Project	<b>IEEE 802.16 Broadband Wireless Access Working Group</b> < <a href="http://ieee802.org/16">http://ieee802.org/16</a> >
Title	<b>Proposed text and ASN.1 code to support MOB_PAG-ADV</b>
Date Submitted	<b>2007-03-13</b>
Source(s)	Joey Chou Intel Corporation <a href="mailto:joey.chou@intel.com">[mailto:joey.chou@intel.com]</a>
Re:	
Abstract	This contribution proposes the text and ASN.1 code in wmanIf2mMib to support MOB_PAG-ADV message.
Purpose	Adoption
Notice	This document has been prepared to assist IEEE 802.16. It is offered as a basis for discussion and is not binding on the contributing individual(s) or organization(s). The material in this document is subject to change in form and content after further study. The contributor(s) reserve(s) the right to add, amend or withdraw material contained herein.
Release	The contributor grants a free, irrevocable license to the IEEE to incorporate material contained in this contribution, and any modifications thereof, in the creation of an IEEE Standards publication; to copyright in the IEEE's name any IEEE Standards publication even though it may include portions of this contribution; and at the IEEE's sole discretion to permit oth

Figure 19—wmanIf2mBsCm structure

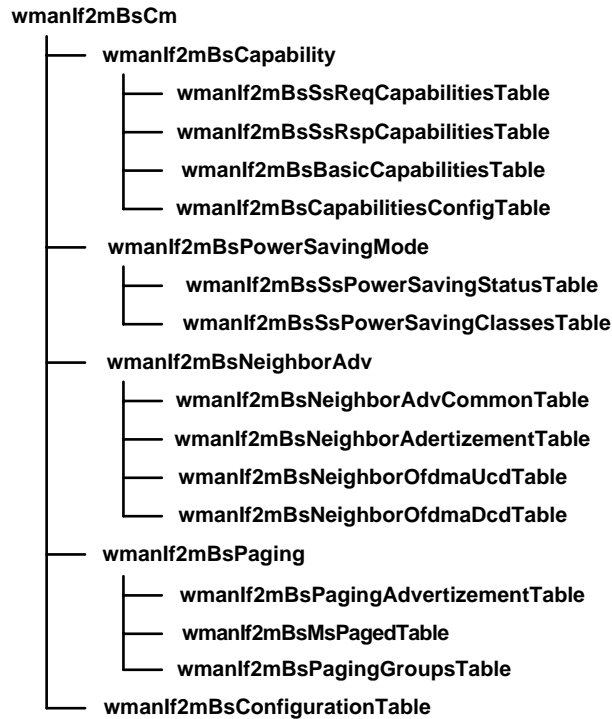
[Change Figure 19 as the following:]
